DEVELOPMENT APPLICATION

PDPLANPMTD-2026/058902

PROPOSAL: Signage, Seven warehouses (Storage) and Car Rental Facility (Transport Depot and Distribution)

FURTHER INFORMATION REQUEST - PLANNING APPLICATION - PDPLANPMTD-2026/058902 - 32 KENNEDY DRIVE, CAMBRIDGE WITH ACCESS FROM MCRORIE COURT

Warehouse 1 & 2 - West Elevation

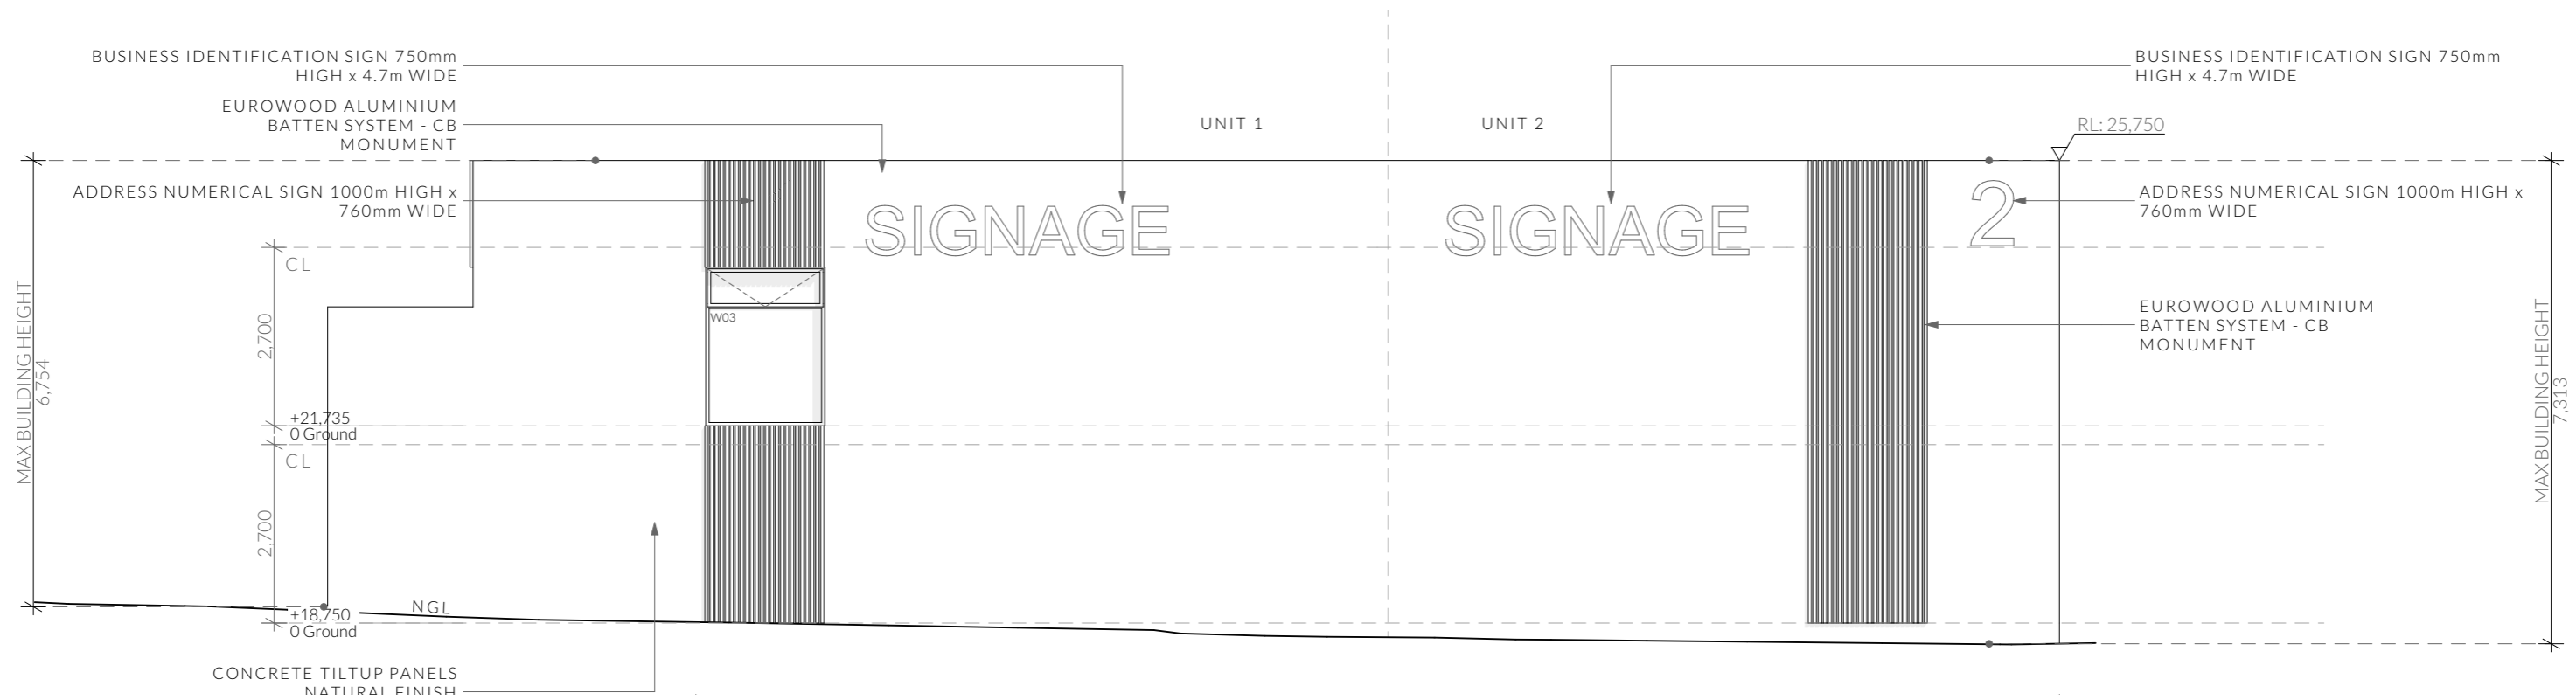
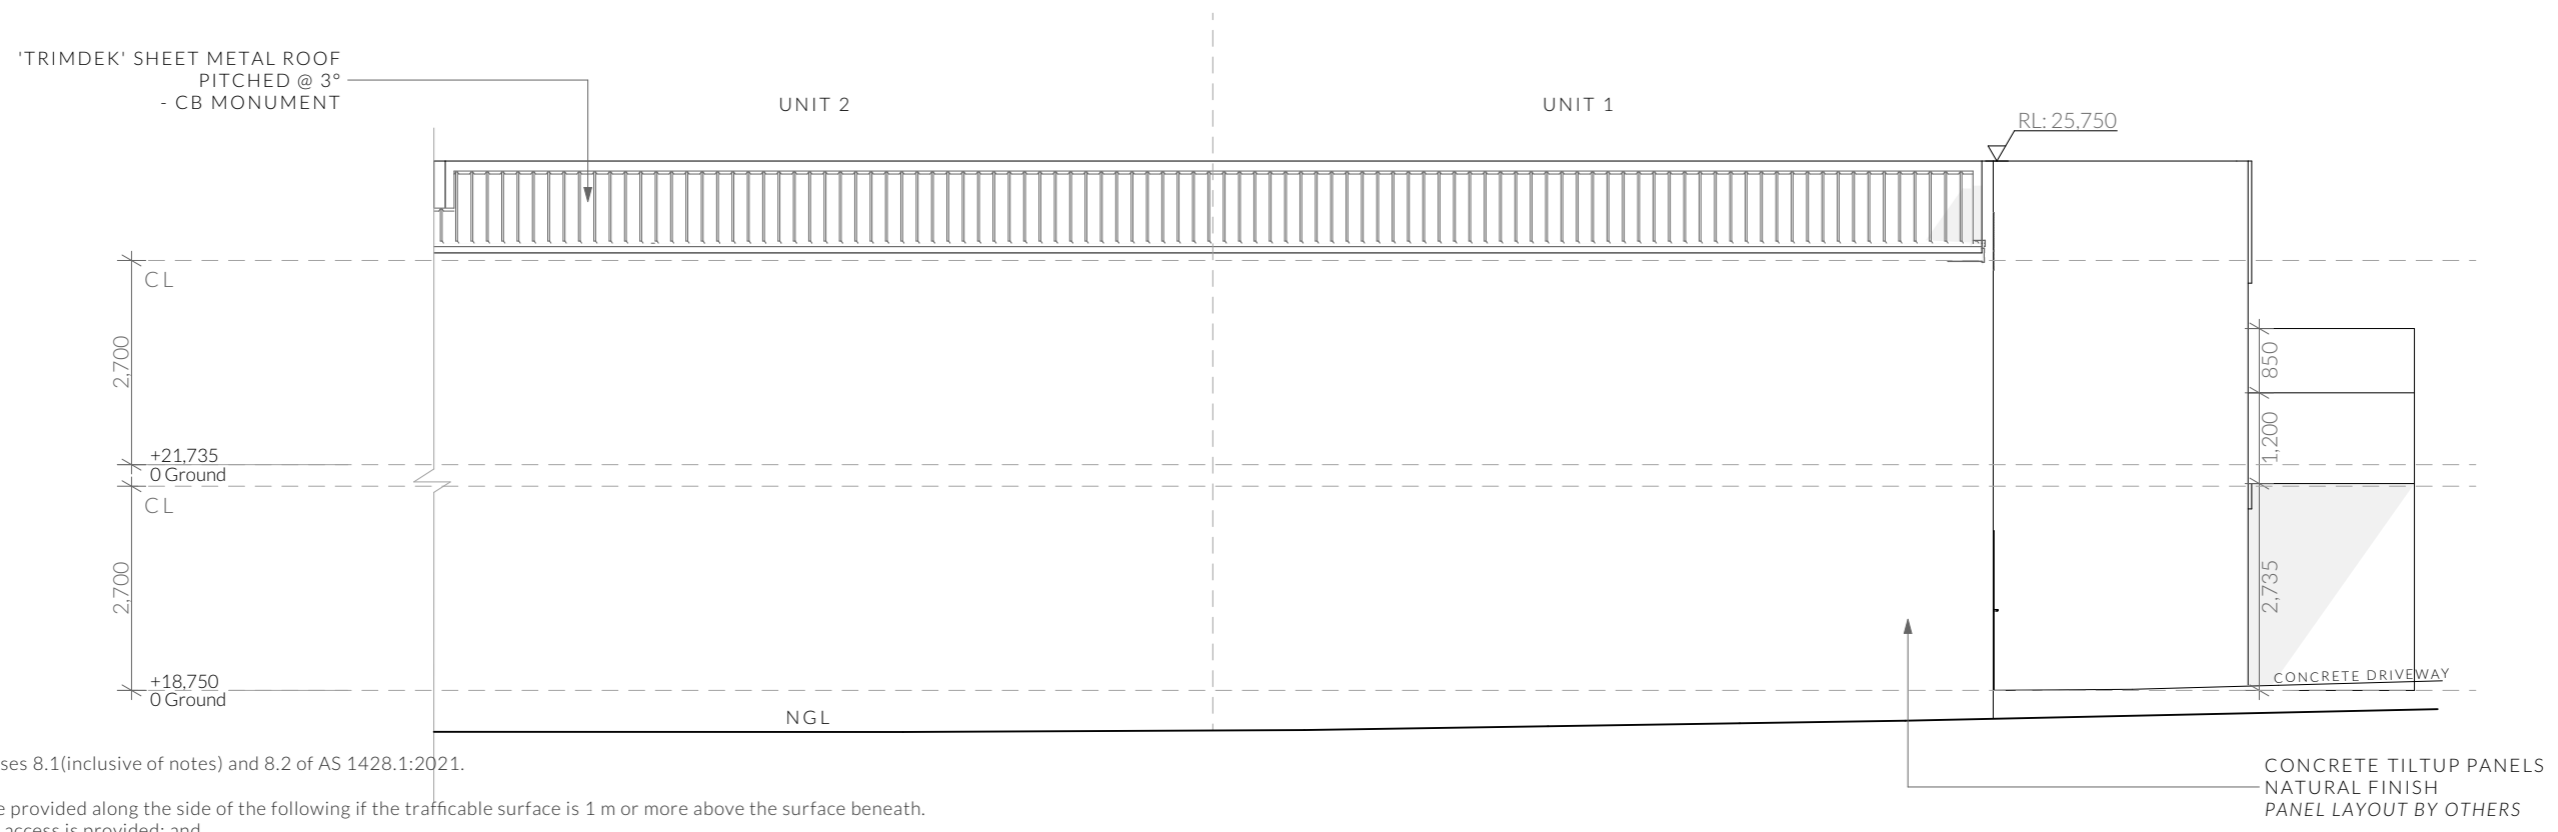
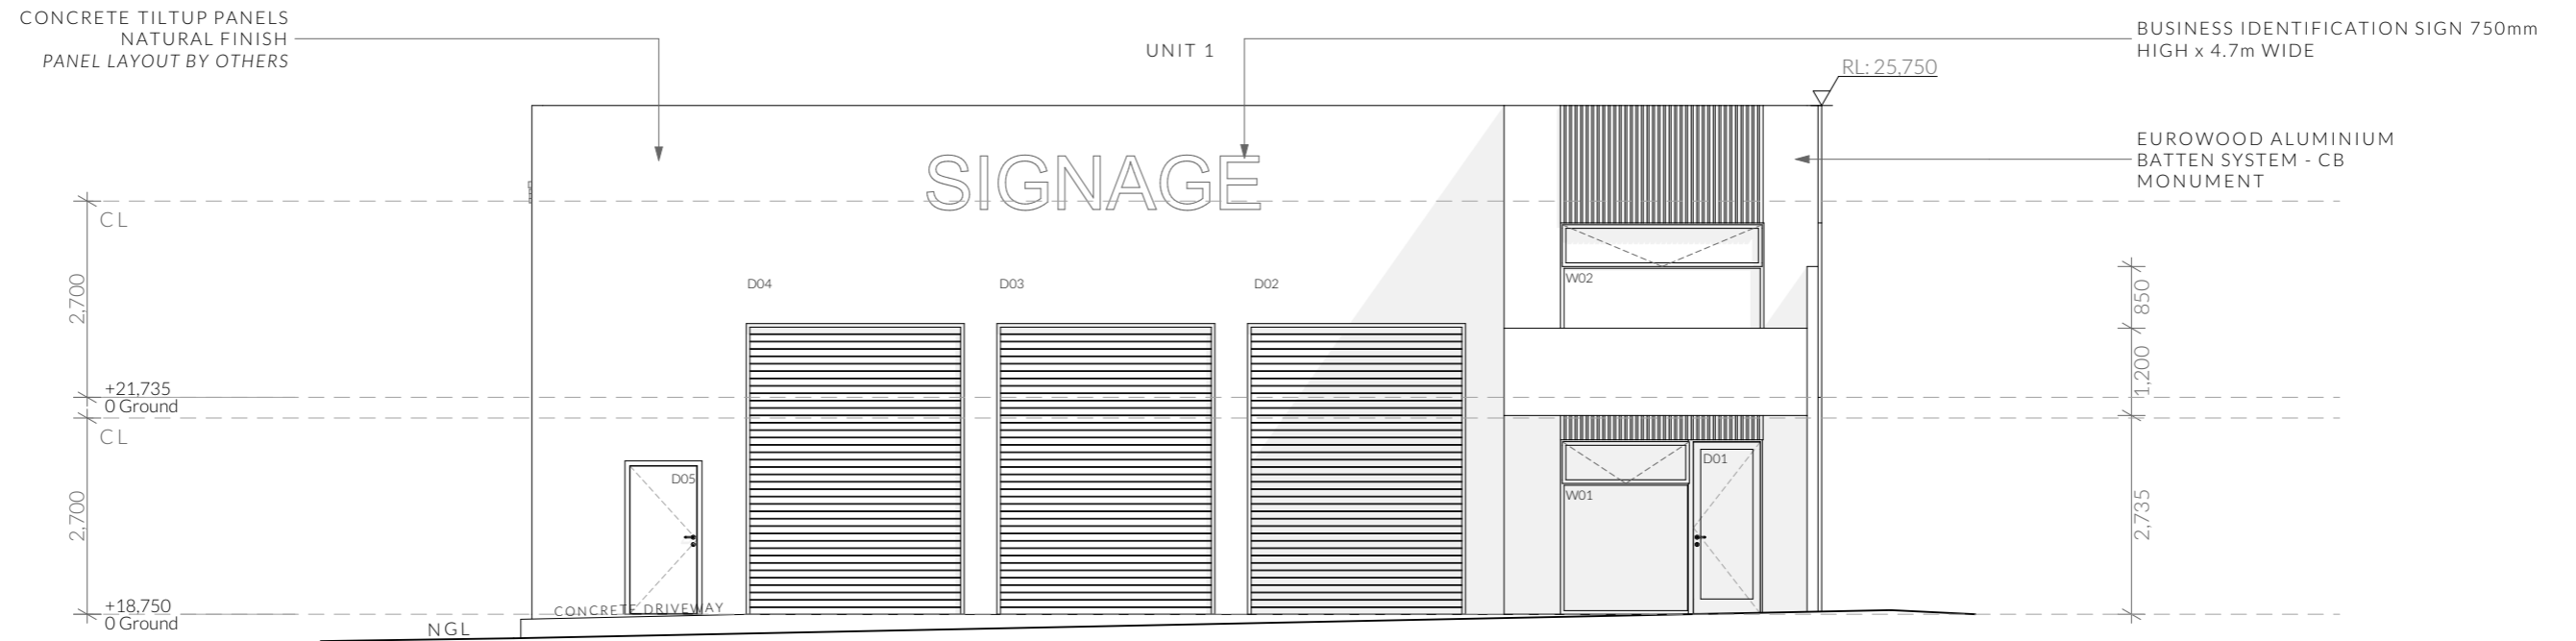
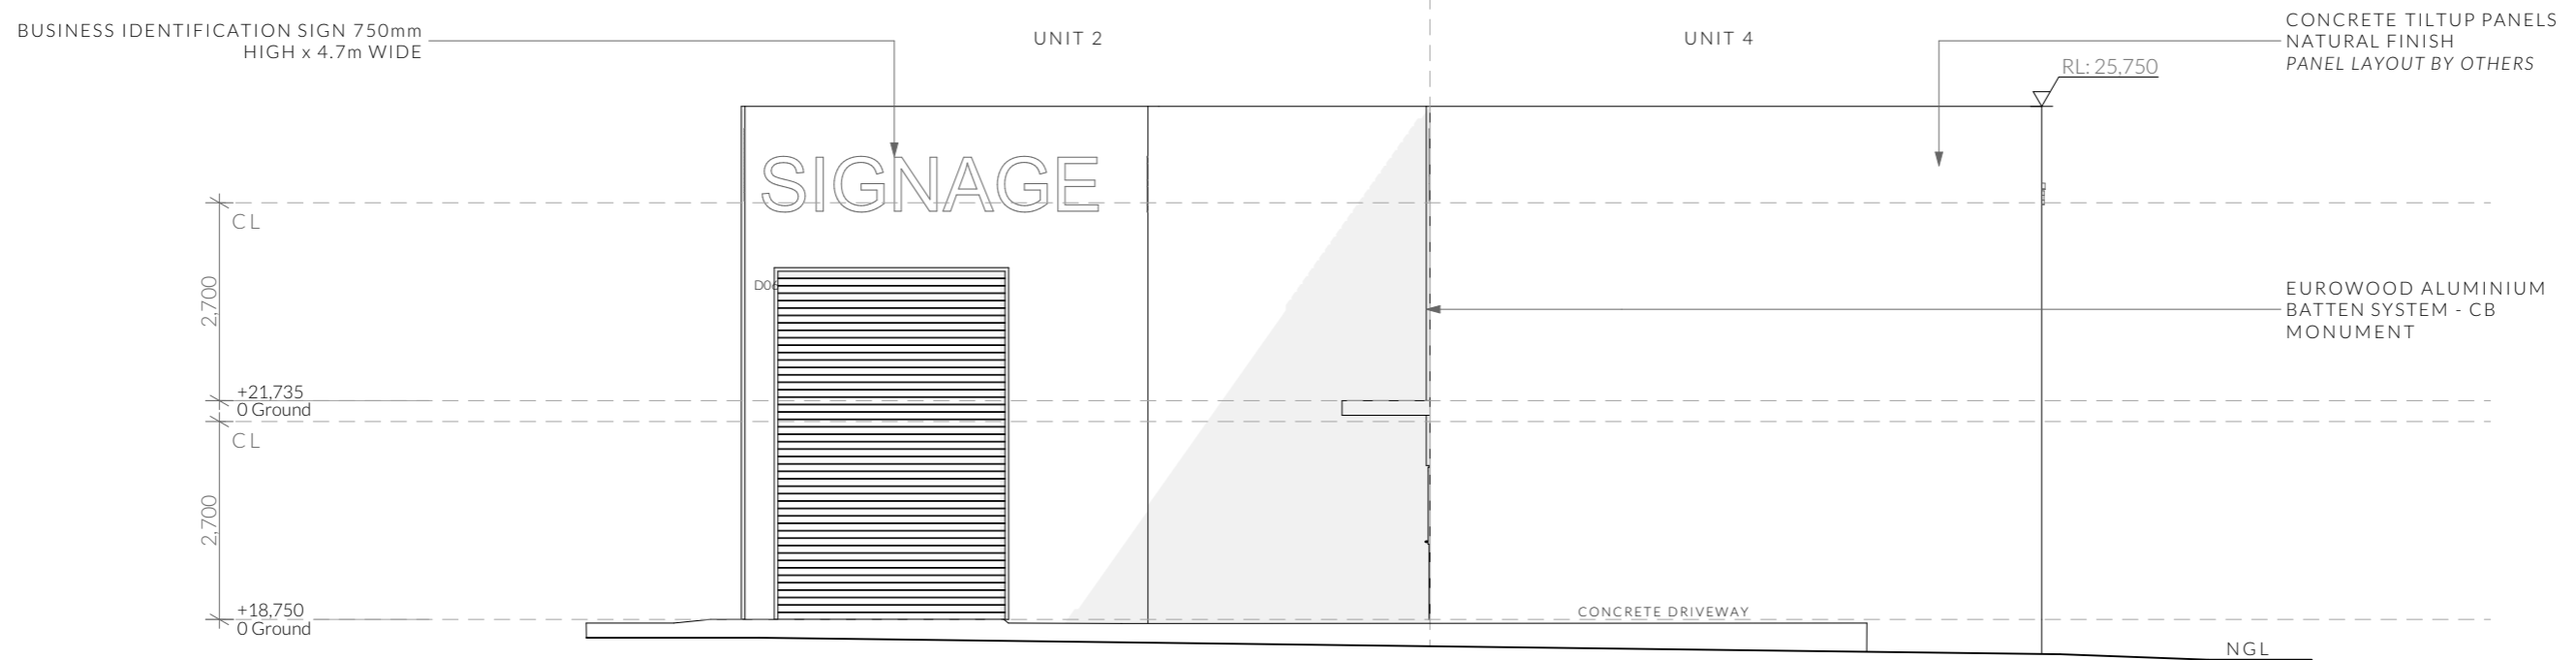
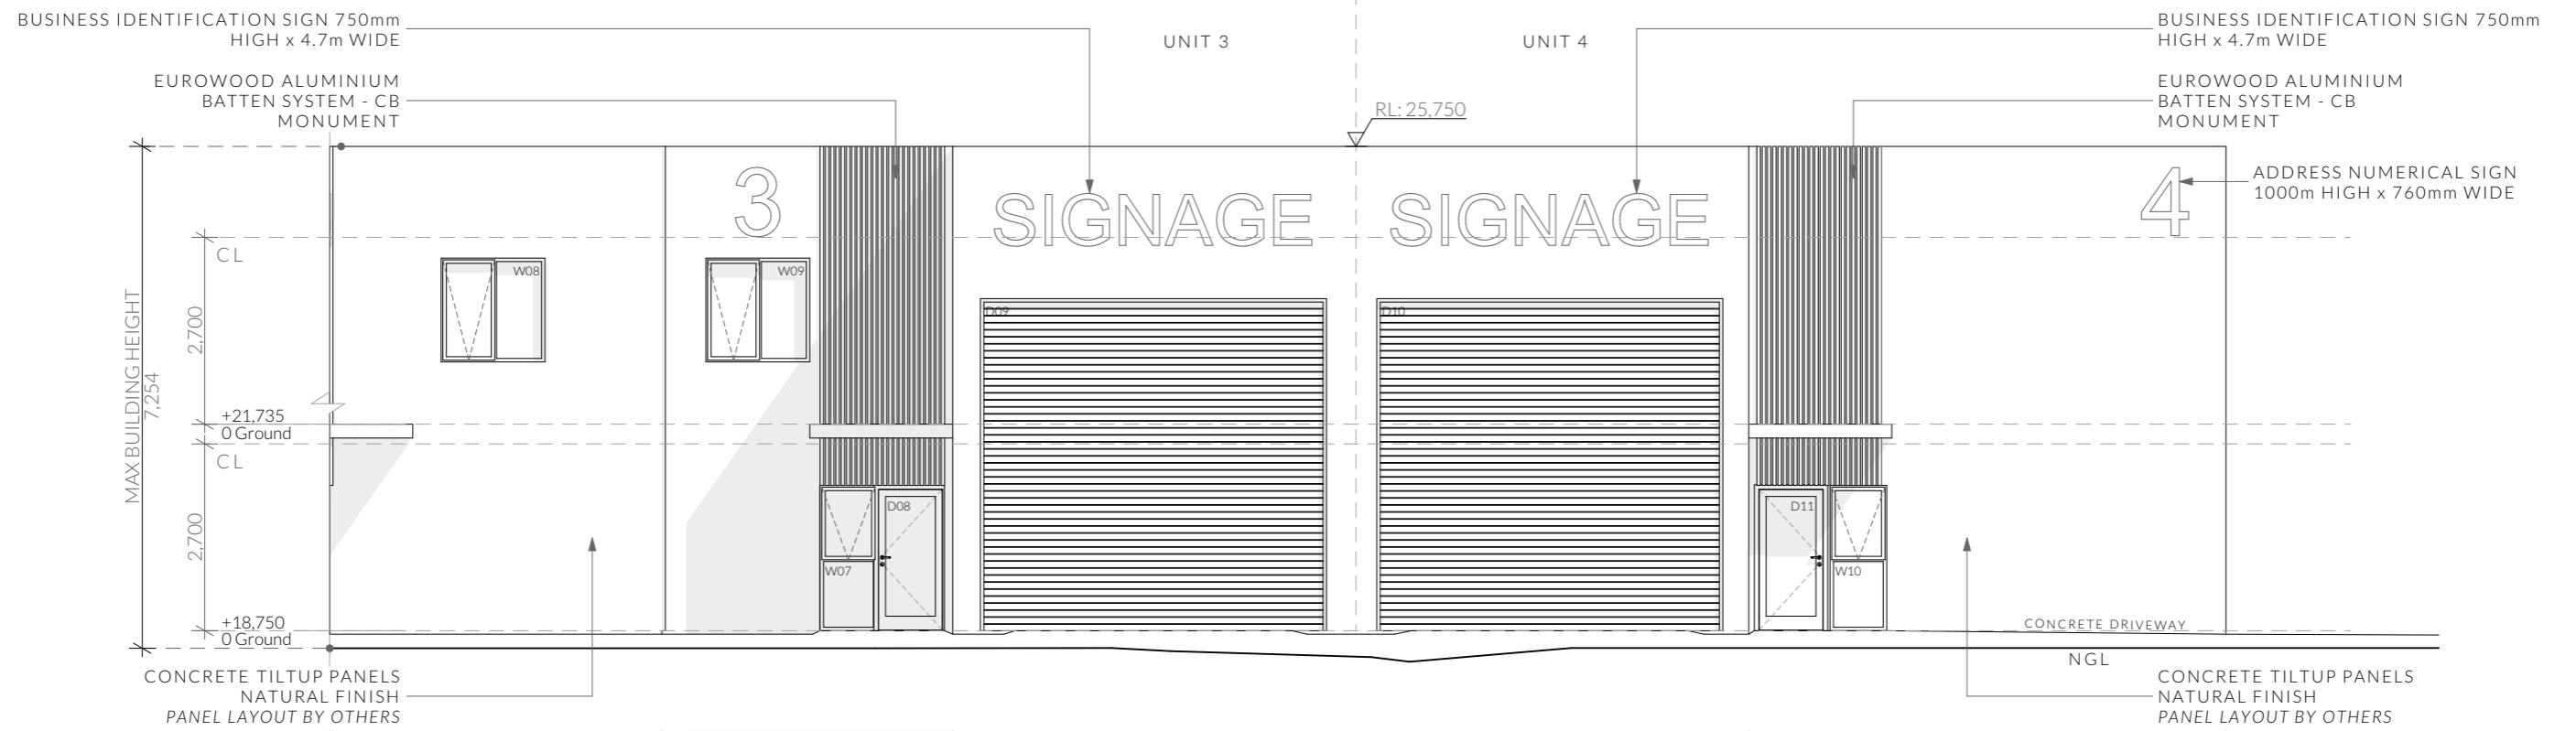
Clause 18.4.1 A1 Building height - Revised elevation plans detailing the maximum height of each tenancy in relation to modified and existing ground level.

Response: Updated plans are provided (Attachment 2) that show that the maximum height of each tenancy complies with 18.4.1 A1 which requires building height to be not more than 10m.
